T.E.D.S. Exception for the Site Plan of Van Gundy's Recycle Center/Salvage Yard

Date: April 4, 2006

Re: Design Exception #DE6-13, 14, 15, 16 – Van Gundy's Proposed site on 4th Ave.

DESIGN EXCEPTION #DE 6-13, 14,15 & 16

TITLE:	EXHIBIT "A"	SCALE:	N.T.S.	DATE:	04/04/06	DRAWN BY:	GAP	CAD I.D.#:	Gundy-Site.dwg
						CKD BY:	RWJII	PROJECT#:	F06-026

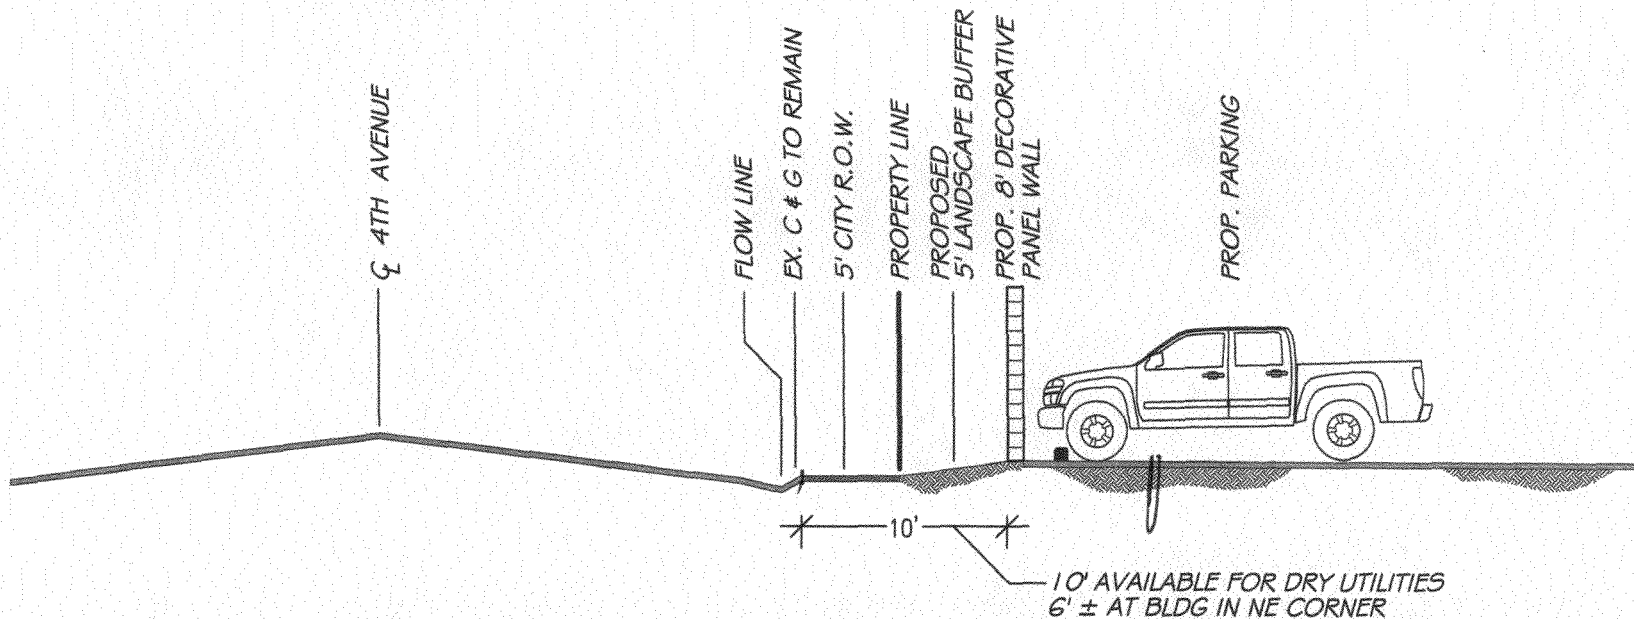
The Site Plan submitted to Community Development does not meet the TEDS standards in regards to providing a 14 Foot Multi Purpose Easement as shown on an Industrial Street Section (attached). As mentioned earlier, this site is approximately 20 percent smaller than the previous site and has more site constraints with the existing buildings and the triangular shape of the new lot. Quite simply, Van Gundy's needs as much room on the site for storage as possible. Additionally, the building in the northeast corner of the Sterling Site is approximately 6 foot from the existing street curb or 1 foot from the property line. A photo is attached as Exhibit A.

EXHIBIT C
COMMUNICATION FROM BRESNAN
SECTION FROM 29 ROAD RECONSTRUCTION

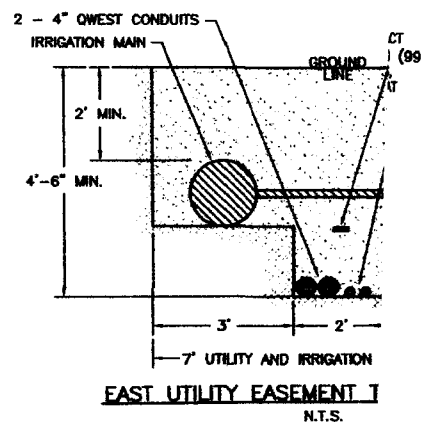
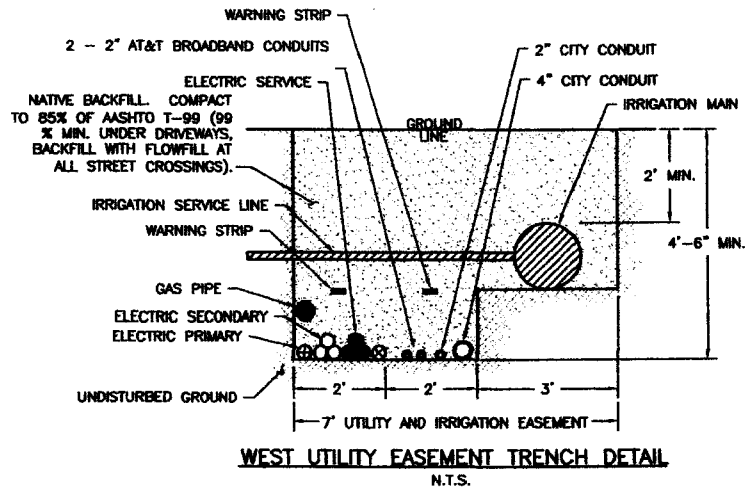
We understand that this easement is for “dry utilities”, Electrical, Cable, and Telephone. Including the area behind the curb, there will be approximately 10 feet for utilities. A sketch is included in Exhibit C. The 50-foot section in front of the building in the northeast corner of the site will have approximately 6 feet for “dry utilities”. We have checked with Xcel Energy, Bresnan Communications, and Qwest about this restriction. Bresnan has indicated approval (included in Exhibit C). We are awaiting comments from Xcel and Qwest.

I am writing in regards to the request to make an exception to the fourteen-foot multipurpose easement in the Van Gundy Simple Subdivision. The request asks for the multipurpose easement to be reduced from the normal fourteen feet to five feet. Bresnan Communications has no objections to this easement exception.

TITLE:
EASEMENT REDUCTION EXHIBIT

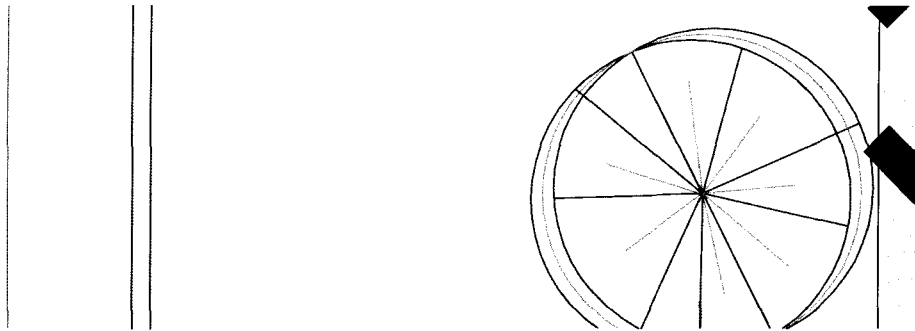
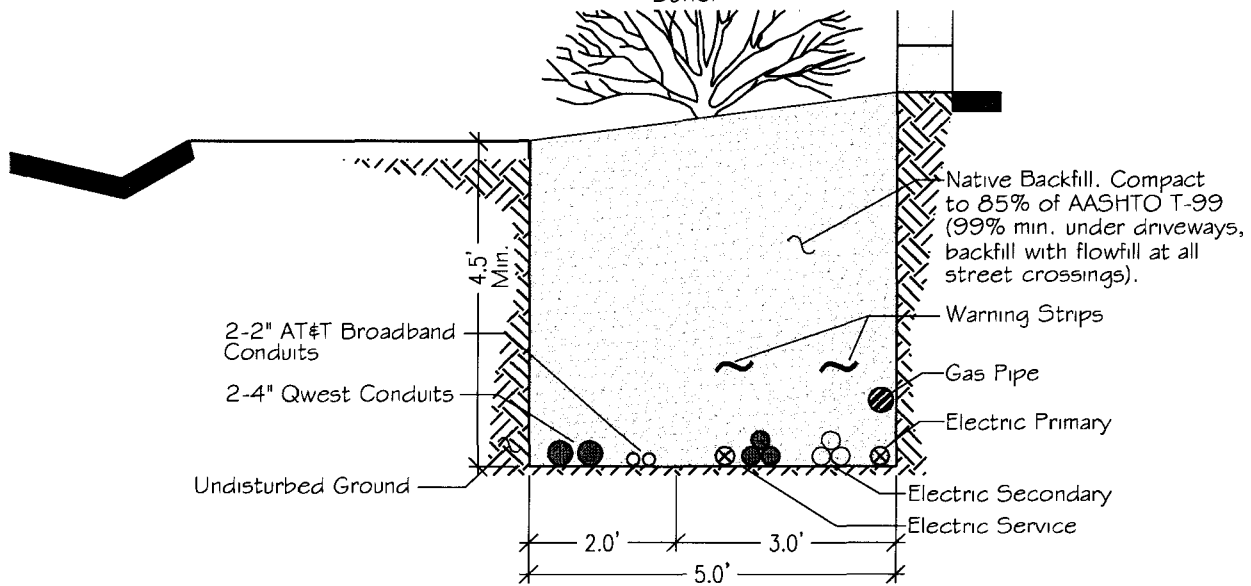
- Reduce to 14-foot multipurpose easement along 4th Avenue to 5 feet
- Eliminate the 14 foot multi purpose easement along 4th Avenue in front of the existing building (This would be for approximately 50 feet and utilities can be placed in the 6 foot section between the building and street curb)

- DE#13 – Approved
DE#14 – Denied
DE#15 – Approved
